N4901A-01A-S

S E R V I C E N O T E

N4901A - Serial Bert 13.5 Gb/s

There is an unlikely possibility of an instrument catching fire due to a short-circuit

Graphics Card

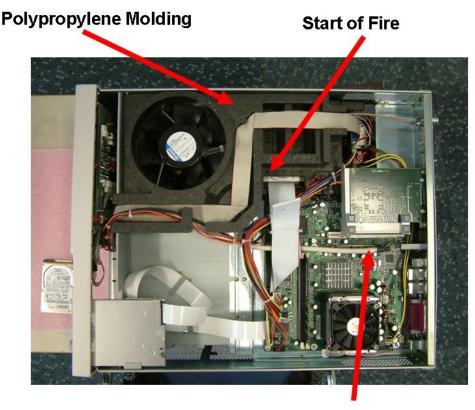
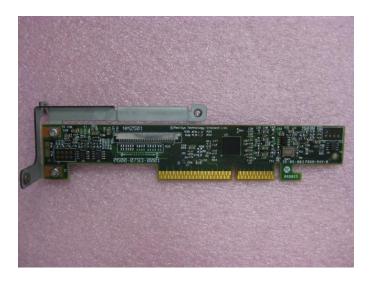
A surface-mount ceramic capacitor suffered physical stress during the manufacturing process, leading the capacitor to crack. During operation this crack placed stress on the internal structure of the capacitor, and caused the plates to short together. (The plates are separated by very little space, made up of very thin insulators.) This caused the capacitor to have very low residual impedance, resulting in a very high current conducted through the capacitor and the 12V path on the motherboard for some period of time. The low impedance didn't lead to a current high enough for blowing the fuse. Therefore the higher current was available long enough to create a very high temperature ($T > 300^{\circ}C$) The high temperature ignited the polyurethane molding used to conduct the airflow for cooling through the instrument.

The following photo illustrates the layout of the instrument. If shows the polypropylene molding, the graphics card and the starting point of the fire.

The countermeasure for this issue is to exchange the graphics cards. The new graphics cards are produced with an improved manufacturing process eliminating the risk of micro cracks. They either have an additional fusing to protect the 12V path or they have eliminated the 12V path altogether. The graphics card can be exchanged by Agilent authorized personnel only.

Motherboard still considered being good – no exchange required:

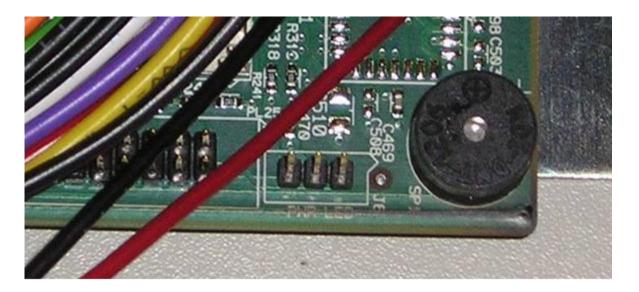
There might be discoloring on the PC motherboard in the shown corner (brown color). This can be ignored. The function or the quality of the motherboard is not affected by this.

Motherboard considered being bad – please exchange:

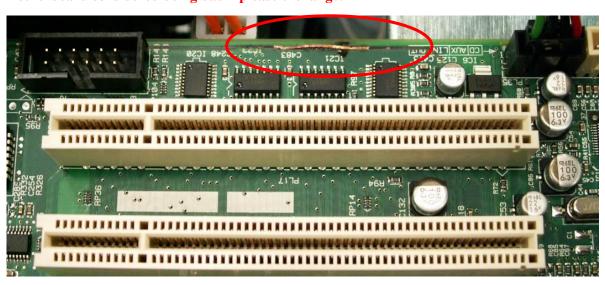
In very exceptional cases if you see traces of smoke or fire, the motherboard needs to be exchanged. In these cases typically the integrated display of the instrument would not work anymore. The exchange of the motherboards can only be done in the Service Center - onsite repair is not possible.

The following discoloring is intentional – no exchange required:

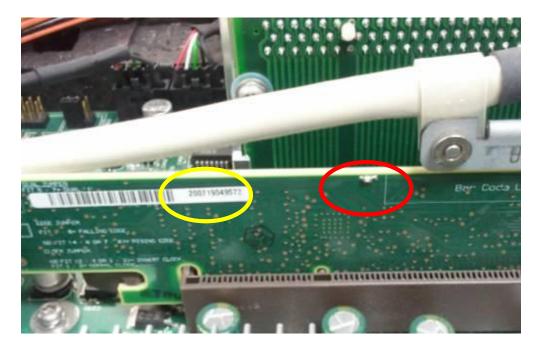
This effect is caused by an intentional sealing of a high impedance area to avoid issues in environments with a high degree of humidity. No exchange of the motherboard is required here.

Sample #1 (Revision NM2501):

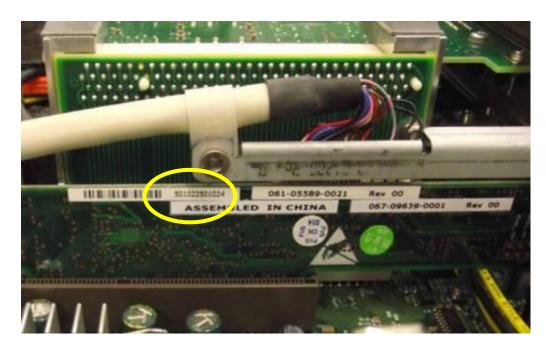
The board has a fuse on top (red circle) and a serial number (yellow circle) starting with 200... In the case above it is 200719049572)

o Sample #2 (Revision NM2502):

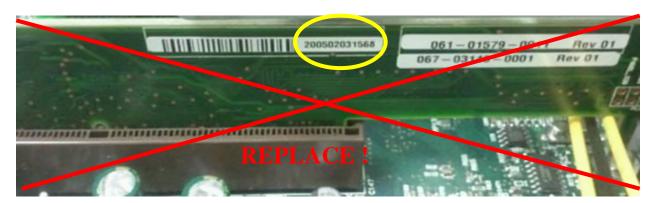
The board has a serial number (yellow circle) ${\bf NOT}$ starting with 200... In the case above it is: 501022501024.

shows a serial number starting with 200... AND no fuse is visible

it is potentially **hazardous** and the **unit must be set out of operation** until the graphic board is replaced (part number: N4901-66577 or N4901-69577). The graphic board can be exchanged without impacting the instrument's performance.
